LiDAR Quality Assessment Report

Materials Received: <input type="text" value="5/15/2012"/>	Project Type: <input type="text" value="GPSC"/>
Project ID: <input type="text" value="San Luis Valley LiDAR"/>	Project Description: <input type="text" value="V13, 1.0 Meter NPS LiDAR"/>
Project Alias(es): <input type="text"/>	Year of Collection: <input type="text" value="2011"/>

San Luis Valley LiDAR

CO_San-Luis-Valley_2011

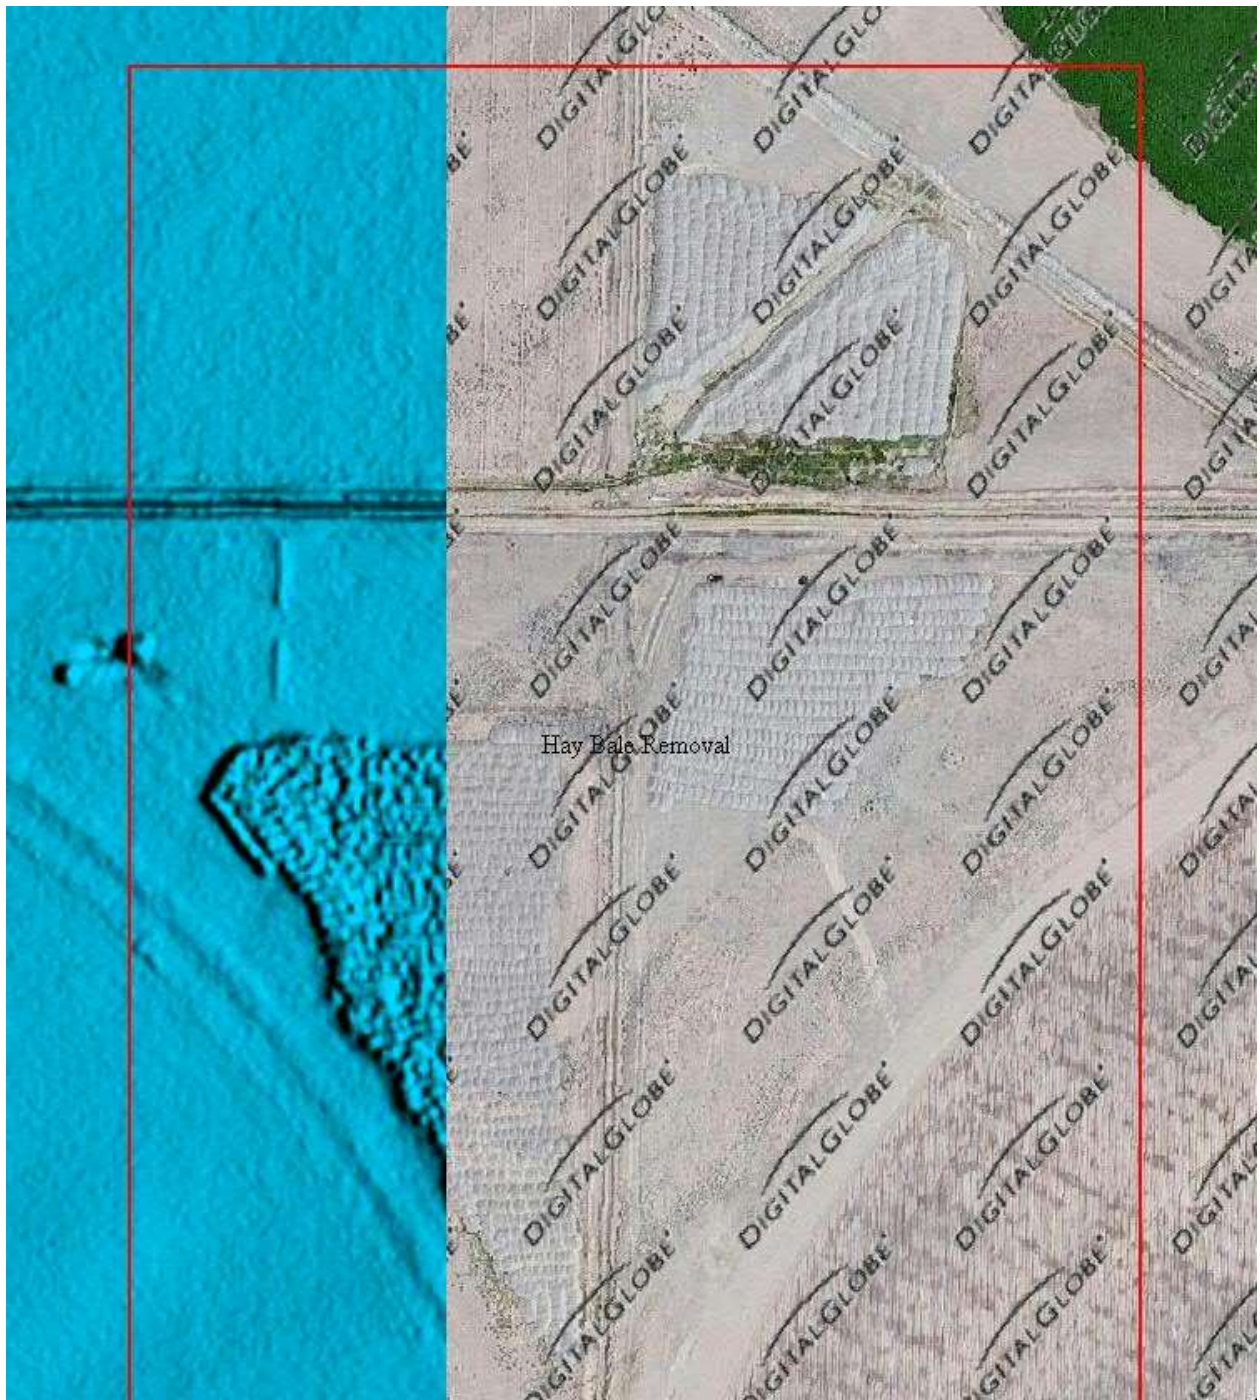
Also relating the harvest is the issue of suspected hay bales near many of the farms and highways. Several Ortho Images and profile graphs suggest the presence of hay bales in the DEMs. Feedback on the treatment of these features in this dataset would be welcome.

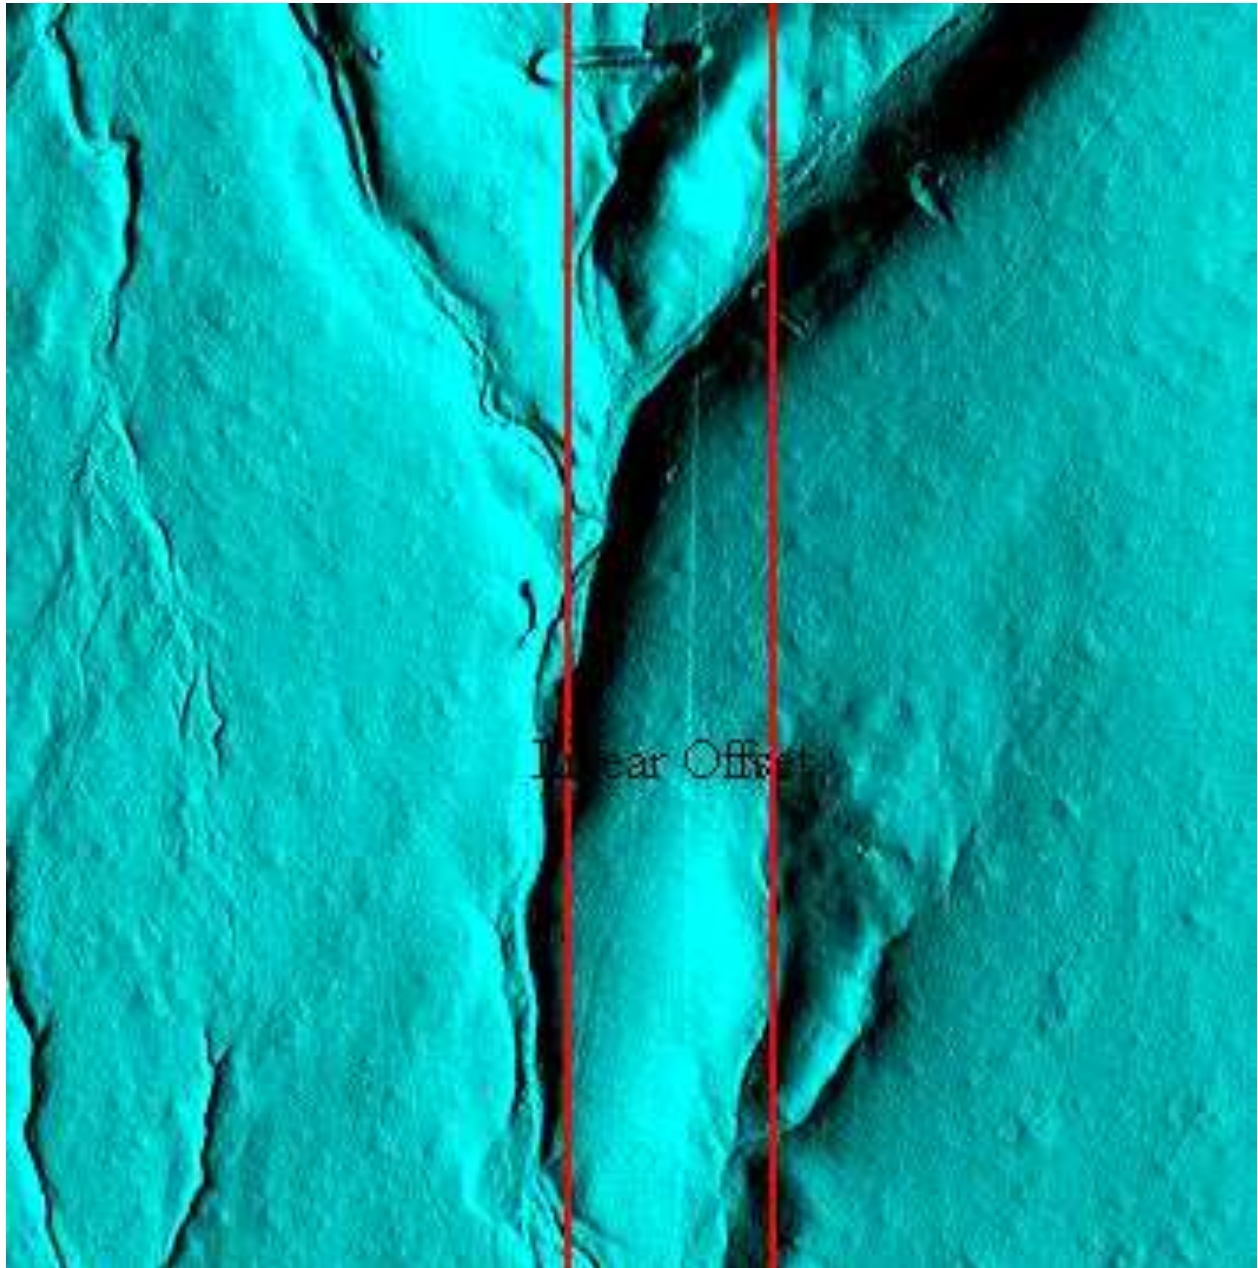
Linear offsets such as the one pictured are rare in the dataset and do not significantly effect the elevations in the DEM. Moreover, it is not clear if this is caused by a genuine calibration/registration issue, natural fault, or software visualization, but the events have been noted and tagged.

Leveling of Waterbodies.

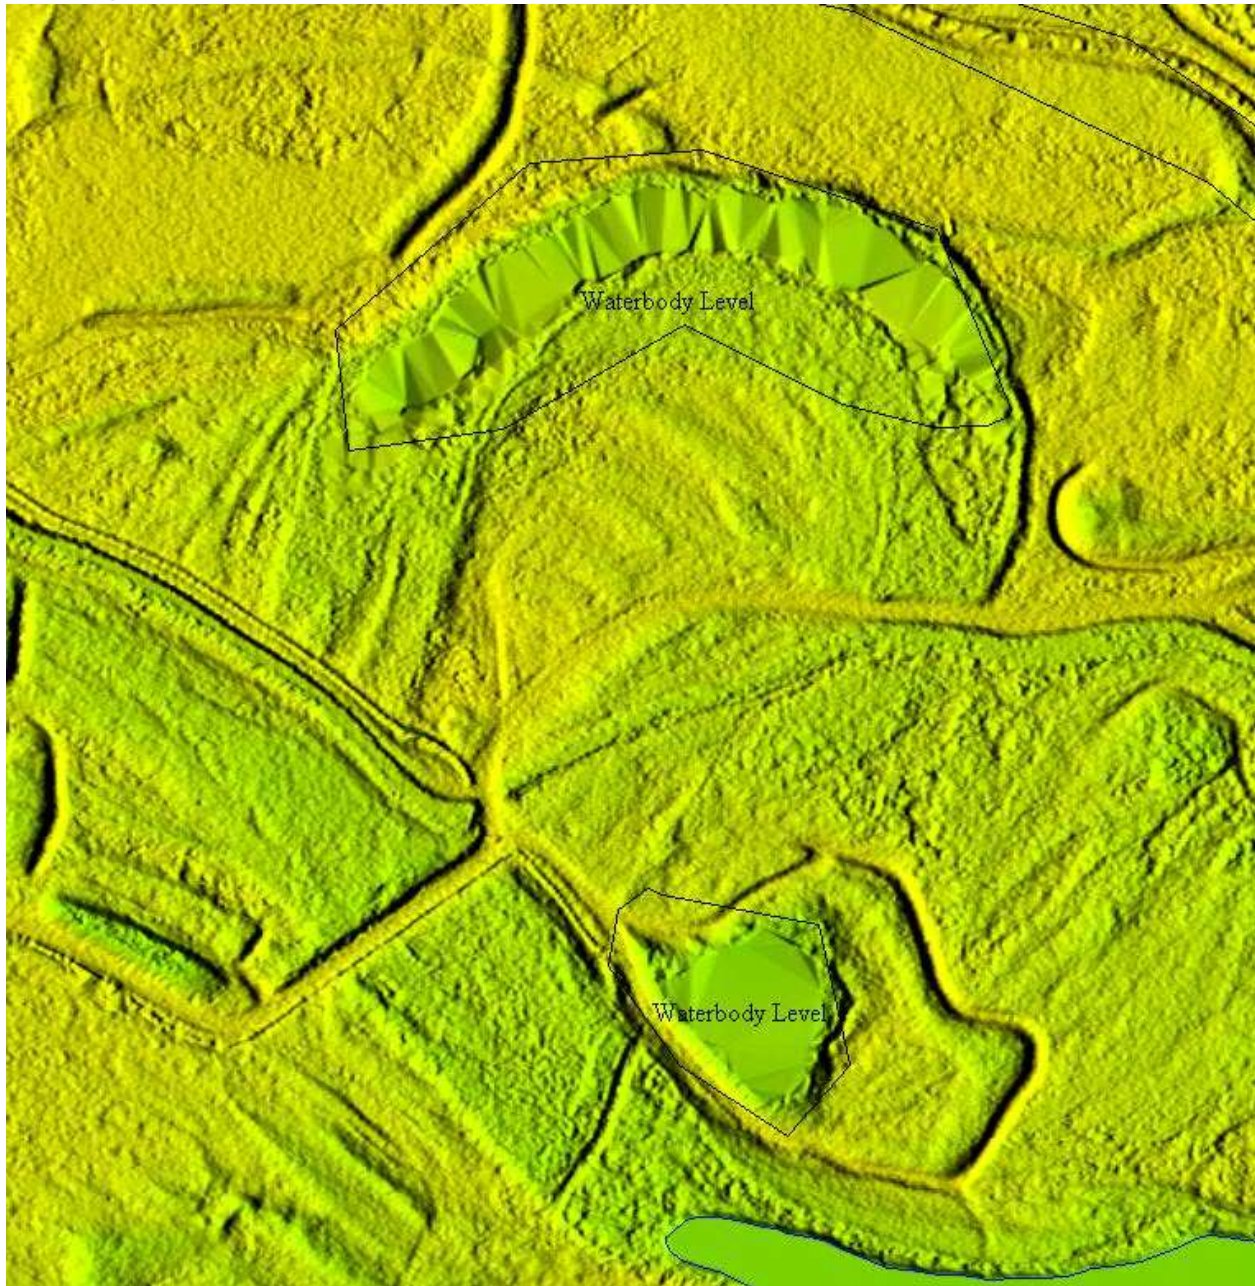
*Update FEMA areas were given full hydro enforcement via the use of additional breaklines and the issues in the images below have been largely corrected. As for the FEMA Area DEMs, they were contracted as to be "Hydro Enforced", which implies heavy use of breaklines to achieve a surface well suited for hydrologic modeling of flow connectivity and flood risk assessment. For this reason, attention to use of breaklines in heavily tinned areas should be especially rigorous. There are quite a few tinned areas in these DEMs which should be appropriately leveled (Waterbodies and Double Line Streams). As well as a few culverts that should be removed. Please see the FEMA_DEM_Error_Tags Shapefile for more information and images below for more information.

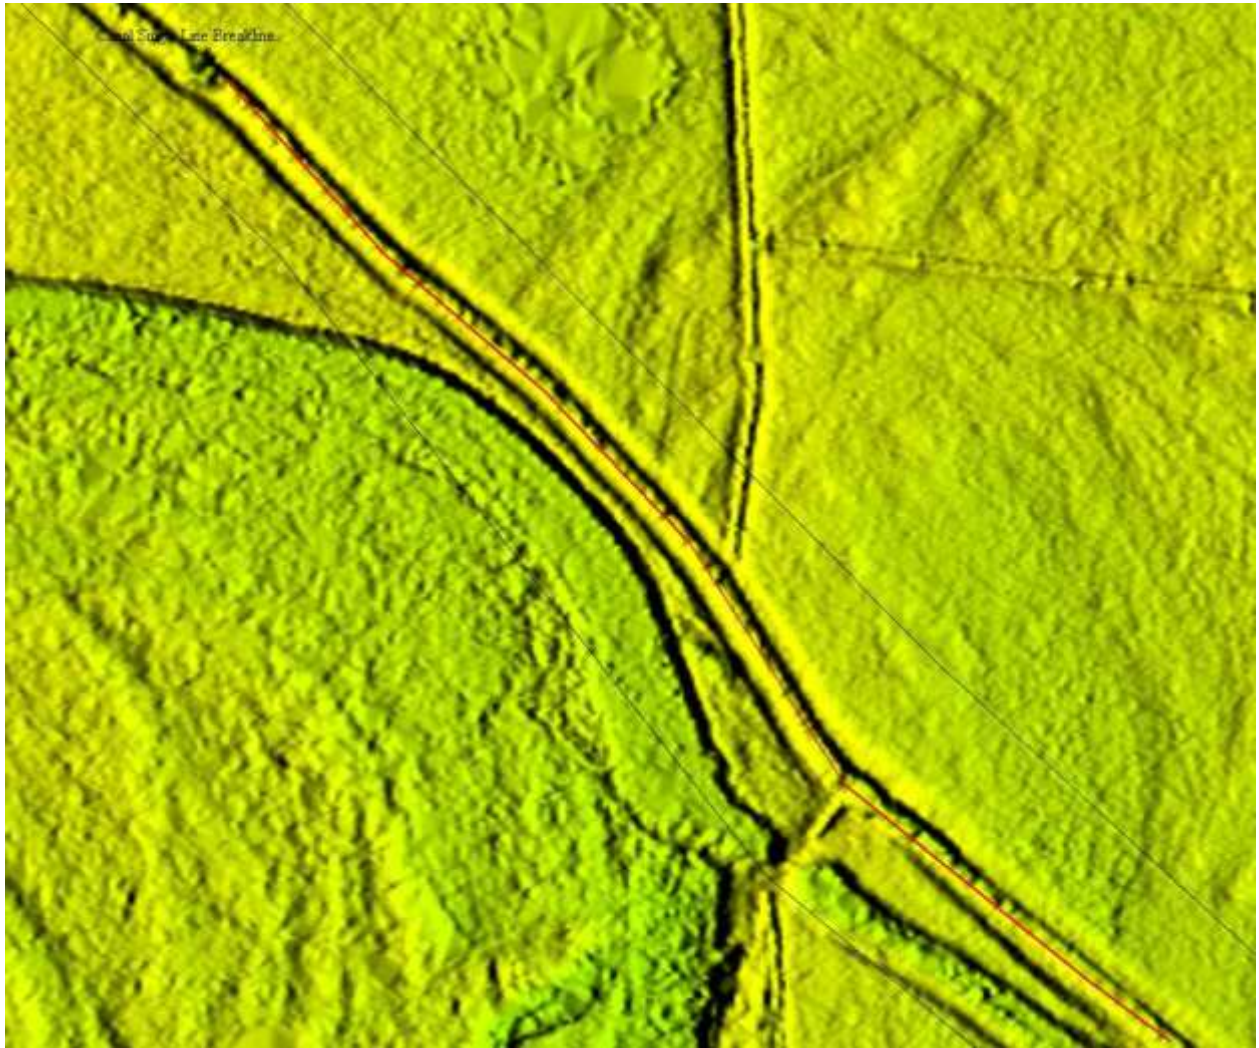
As I understand the term "Hydro Enforced" DEMs/DTMs should make use of single line breaklines to better model flow along narrow channels and canals.

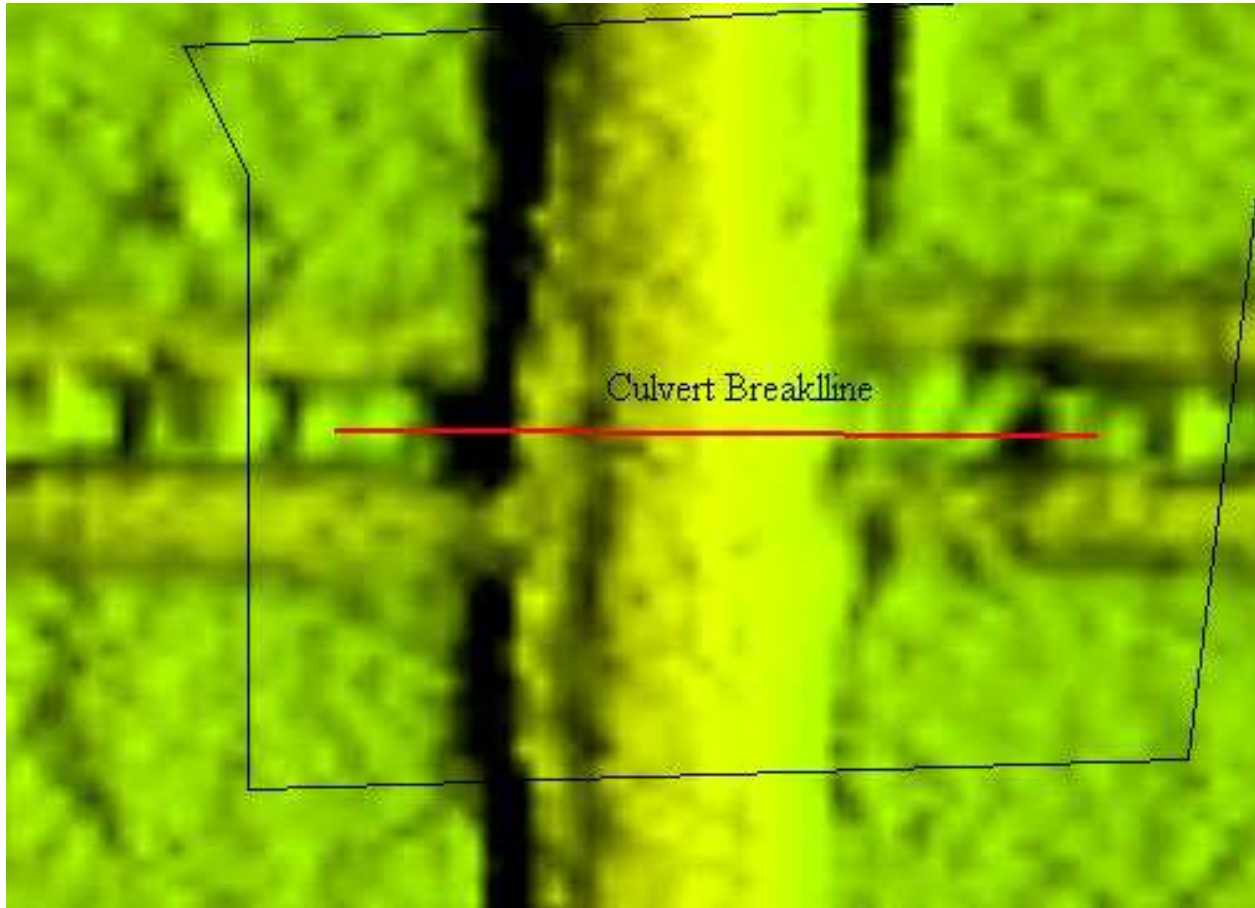
In accordance with the Previous Comment, "Hydro Enforced" models should have connectivity in through features like culverts, meaning the road would be removed at this location and the canal would continue through. In other words, a "Hydro Enforced" DEM depicts hydrographic connection over topographic features; whereas, a "Hydro Flattened" DEM places the onus on Topography over Hydrography.
